URBAN DESIGN COMMITTEE

AGENDA

URBAN DESIGN COMMITTEE STAFF REPORT

APPLICATION NUMBER	Urban Design Record #24002
APPLICATION TYPE	Neighborhood Design Standards Appeal
ADDRESS/LOCATION	4207 Pioneers Boulevard
HEARING DATE	February 06, 2024
ADDITIONAL MEETINGS	-
APPLICANT	Richard Gruenemeyer, rdjhn3vs16g@yahoo.com
STAFF CONTACT	Arvind Gopalakrishnan, 402-441-6361, agopalakrishnan@lincoln.ne.gov

ATTACHMENT B – Site Plan

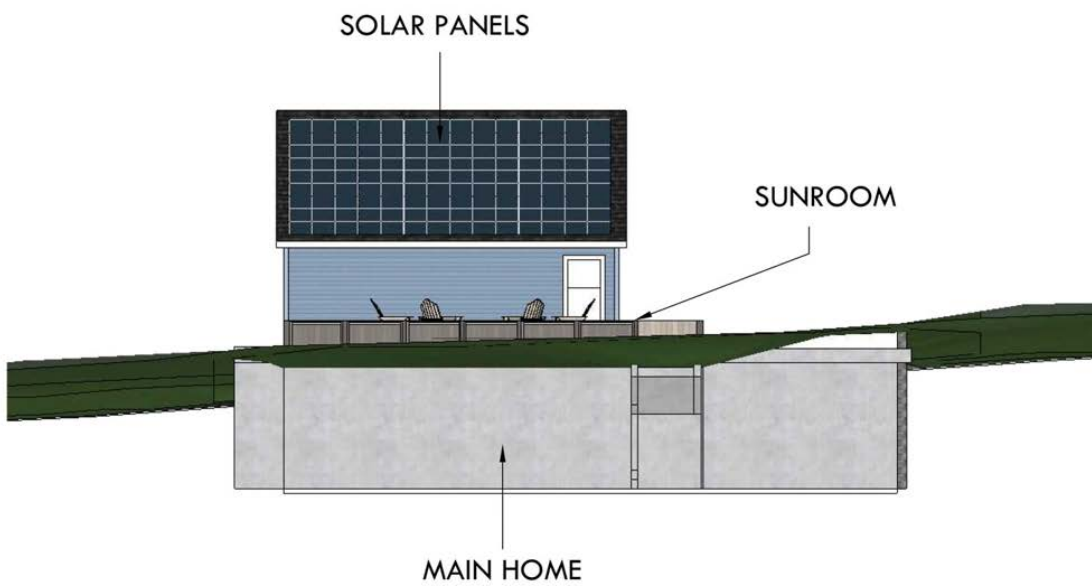
Compatibility per Staff Analysis: *No existing trees are being cut down for this construction. However, the proposal shows a tree that would be planted between the driveway and the sidewalk, to blend with the existing pattern of trees on the block.*

- I appreciate the inclusion of a tree and other landscaping in the plan. They help the structure look more settled in the larger landscape. I encourage the new owners to plant even more after they have finished the project to enhance the overall appearance.

ATTACHMENT B – Elevations

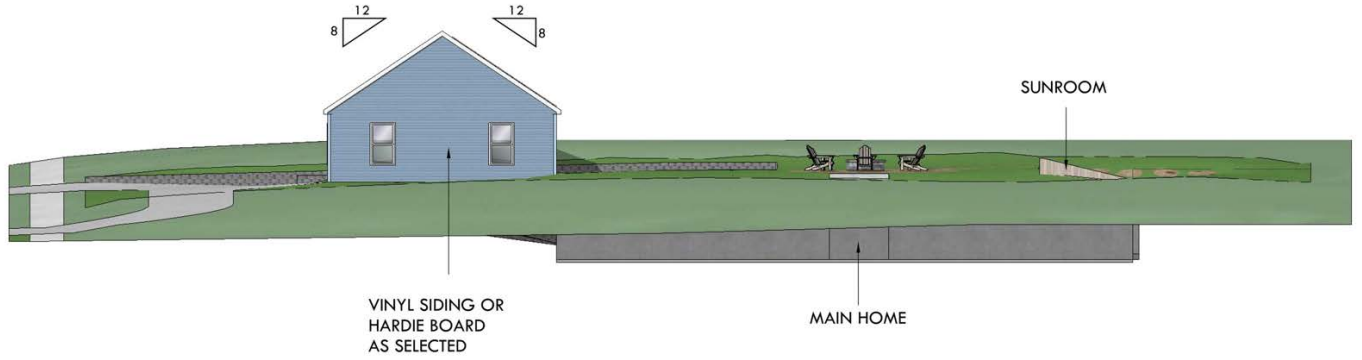
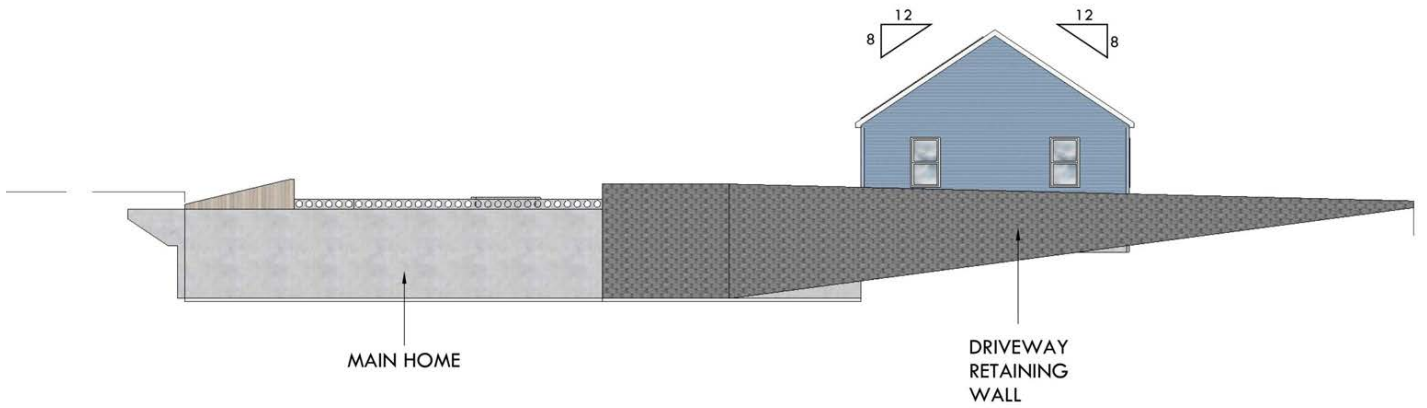
Garage doors do not count as openings. Apart from the garage door, the structure has a door, and a double-hung window fronting the street.

The top panel of the garage door would have two plexiglass panels, and the rest of the garage door would be painted to look like windows and shutters.

- The inclusion of faux windows and shutters on the garage door is unnecessary and detracts from the overall appearance. As the staff comments say, the faux shutters could be painted over so they are not a permanent design feature. Further, it appears that the only requirement is that there be at least one window and one door facing the street which would be met without the faux windows. There is a paved driveway running up to the garage door so the faux windows are not particularly effective at tricking the eye. I would recommend the garage door be opaque instead.

ATTACHMENT C – Landscape Plan

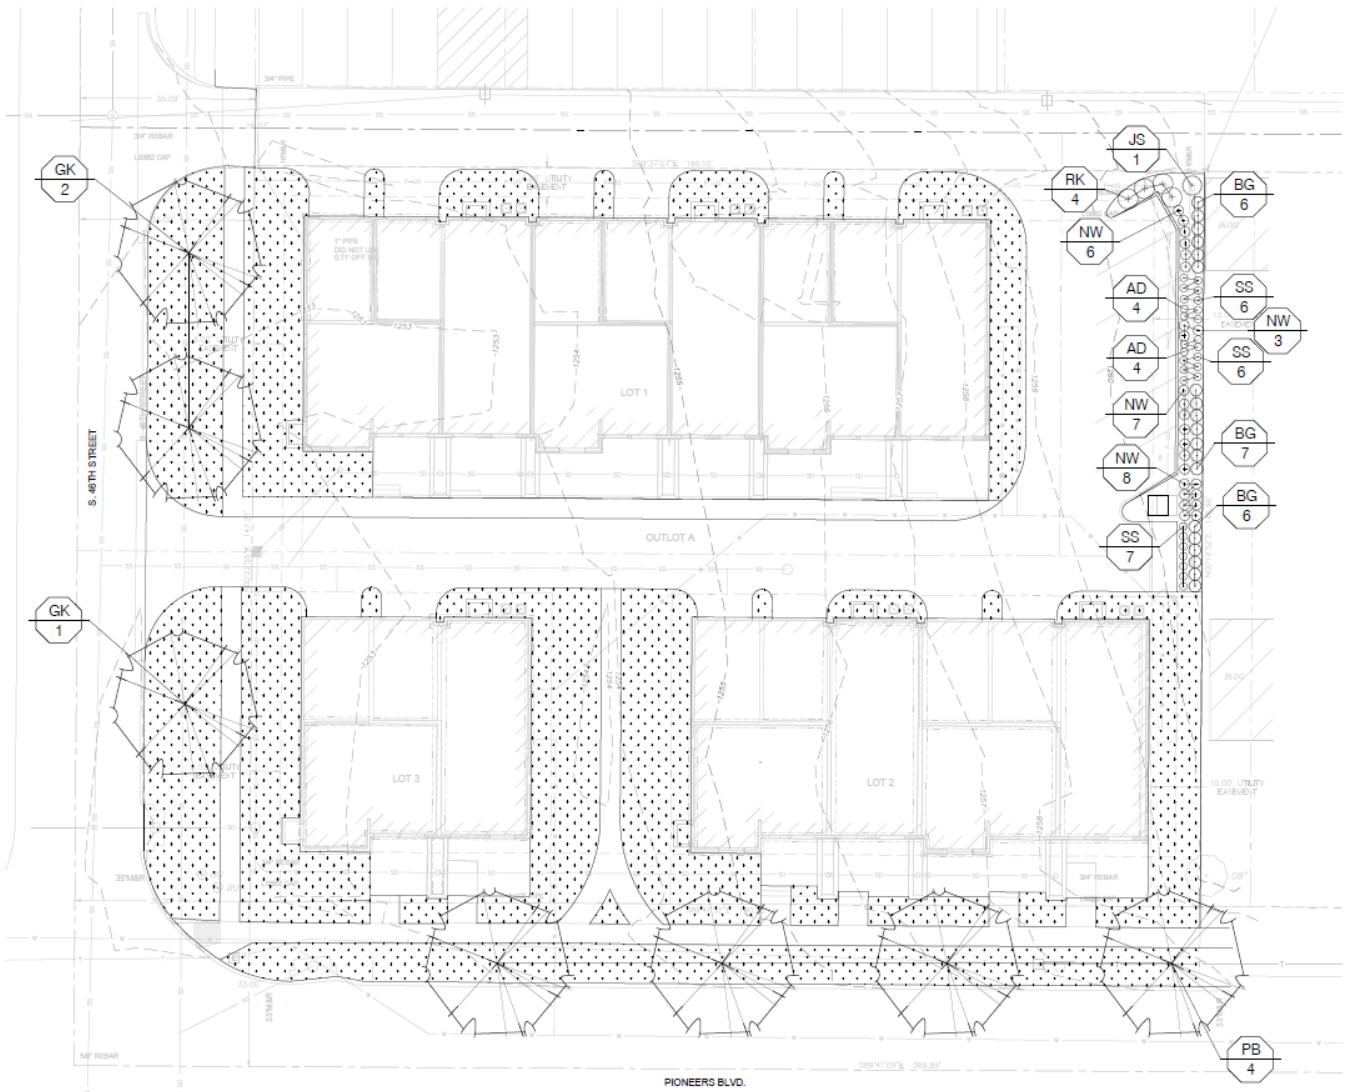
Compatibility per Staff Analysis: *No street trees are being cut down for this construction. However, the proposal shows 7 trees that would be planted as part of the project: 4 along Pioneers Boulevard, and 3 along 46th St., to blend with the existing pattern of trees on the block.*
